SERVICE BULLETIN CHANGE NOTICE

S.B. No. A320-21-1003
Mod. No. 20831/P1160

TITLE : AIR CONDITIONING, EQUIPMENT VENTILATION - INSTALL AIR COOLING FANS
WITH MUFFLERS.

SERVICE BULLETIN No. : A320-21-1003

Installation of Mufflers Around Fans
Figure 1

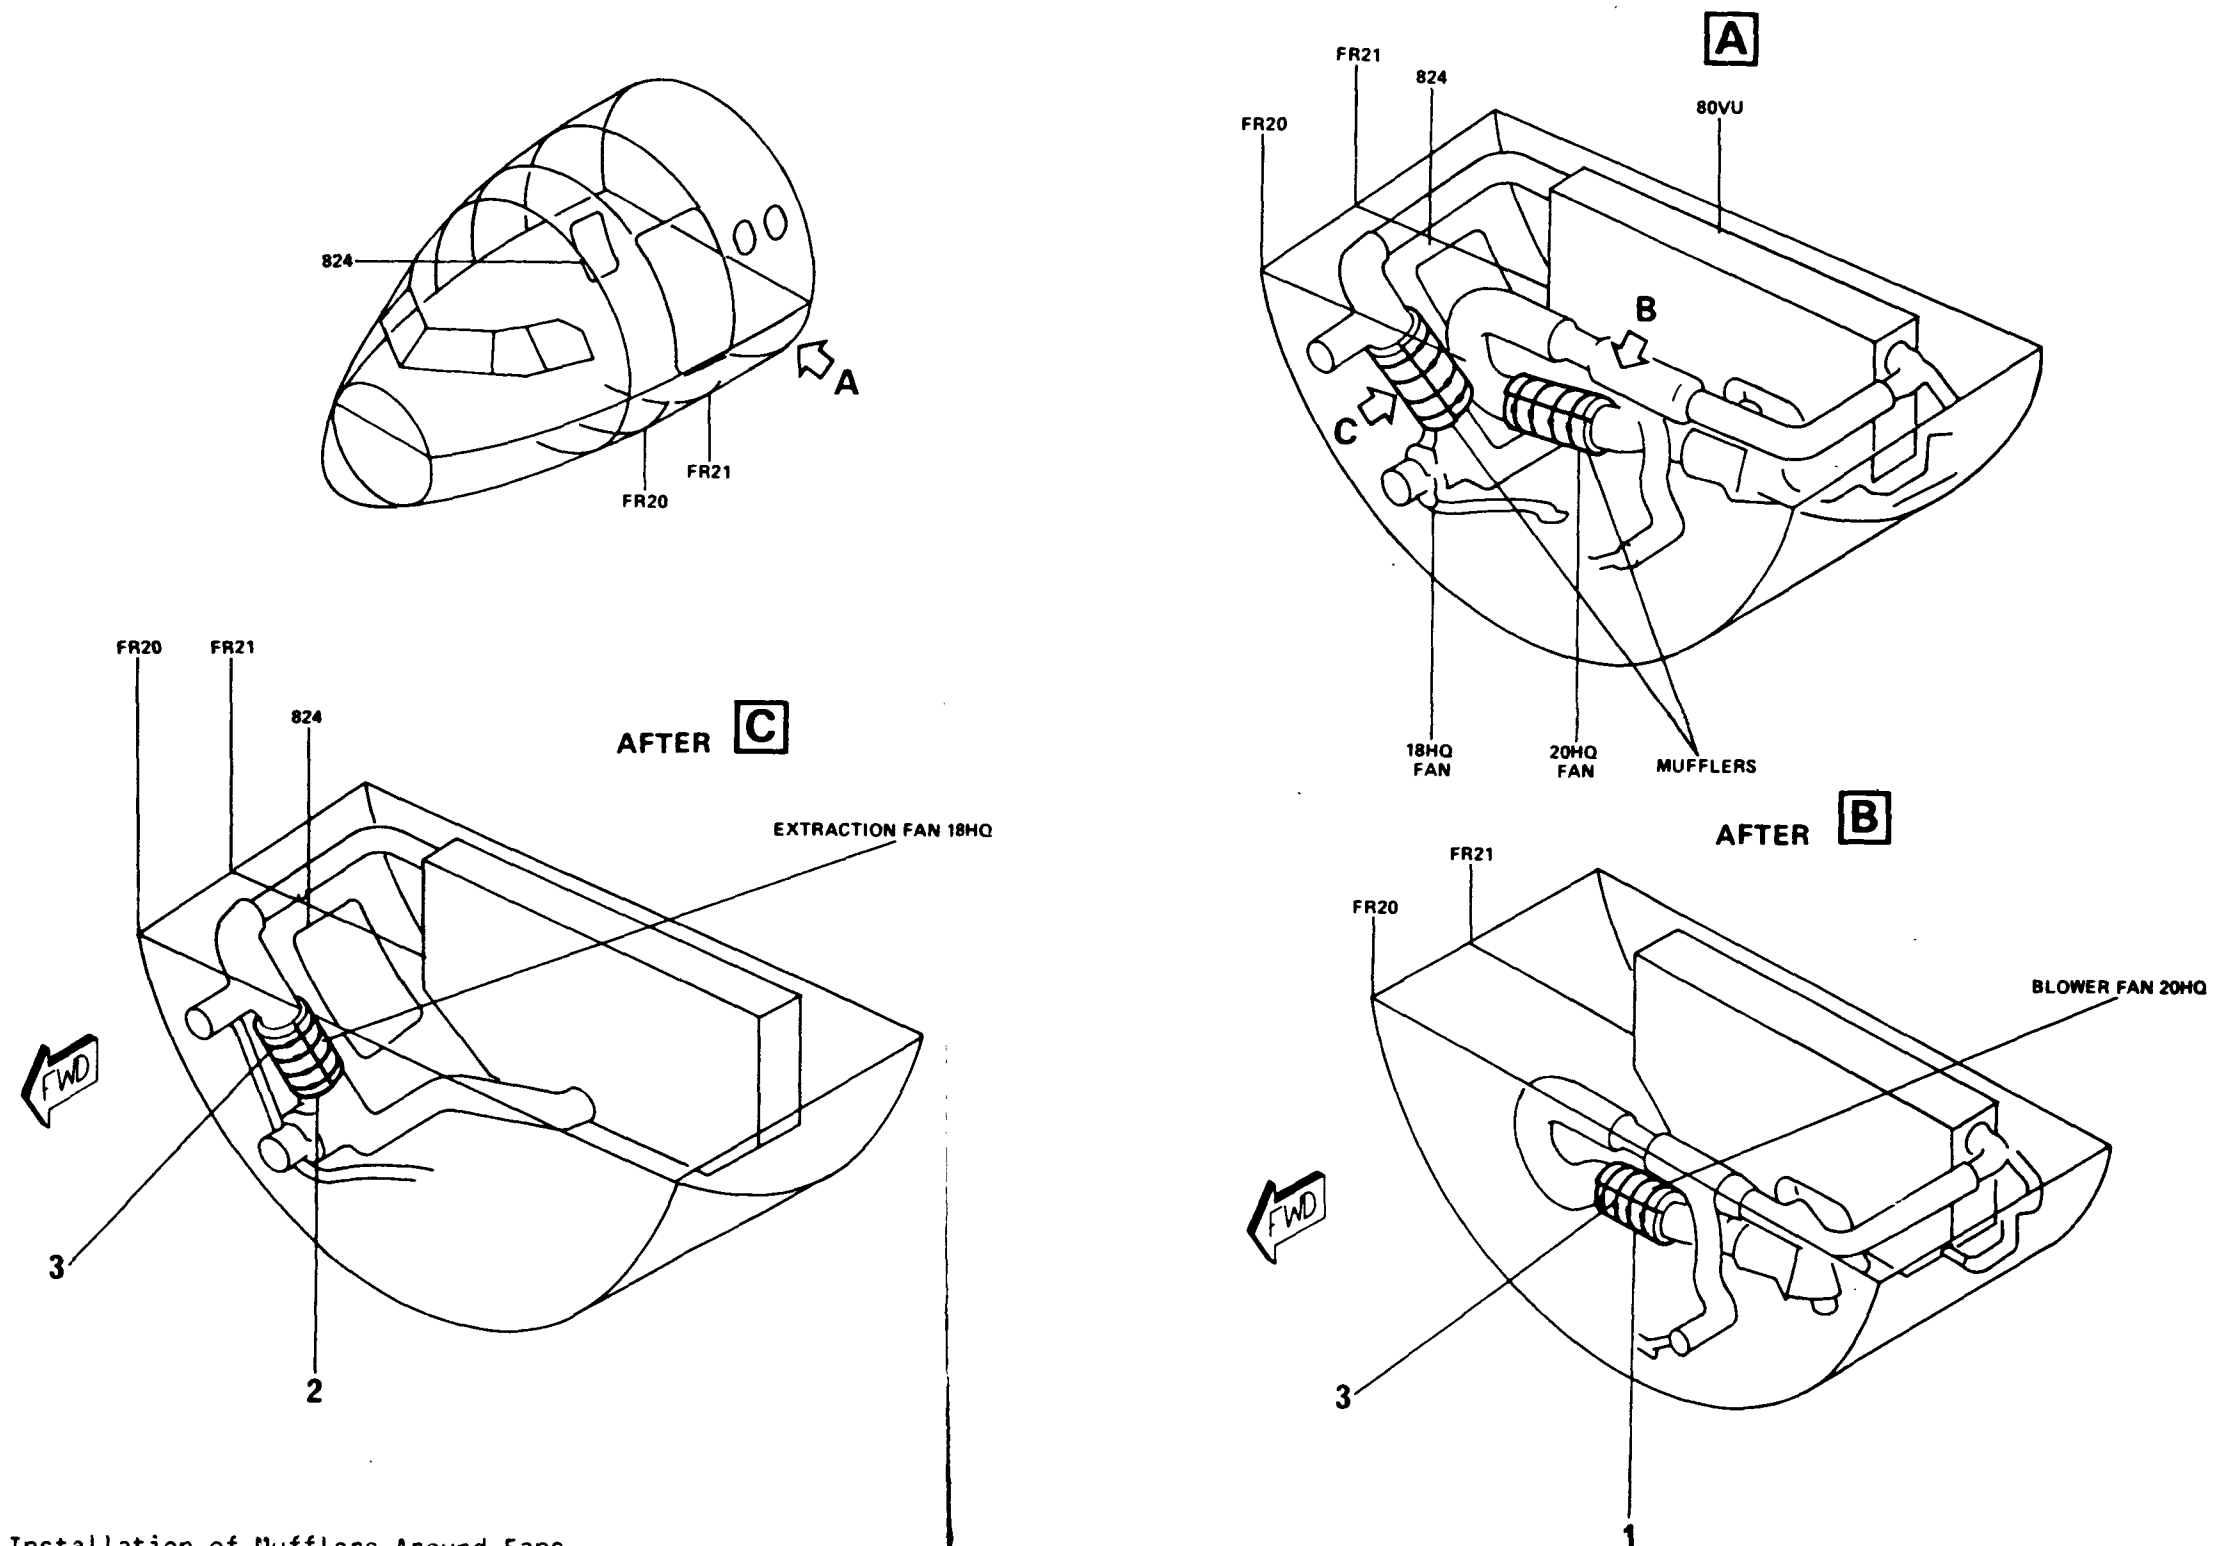
- (2) Install the mufflers
Ref. Fig. 1

- (a) On blower fan 20HQ
 - 1 EVT3454-600-01 Item 1
 - 4 clamps TY29M Item 3

- (b) On extract fan 18HQ
 - 1 EVT3454-600-02 Item 2
 - 4 clamps TY29M Item 3
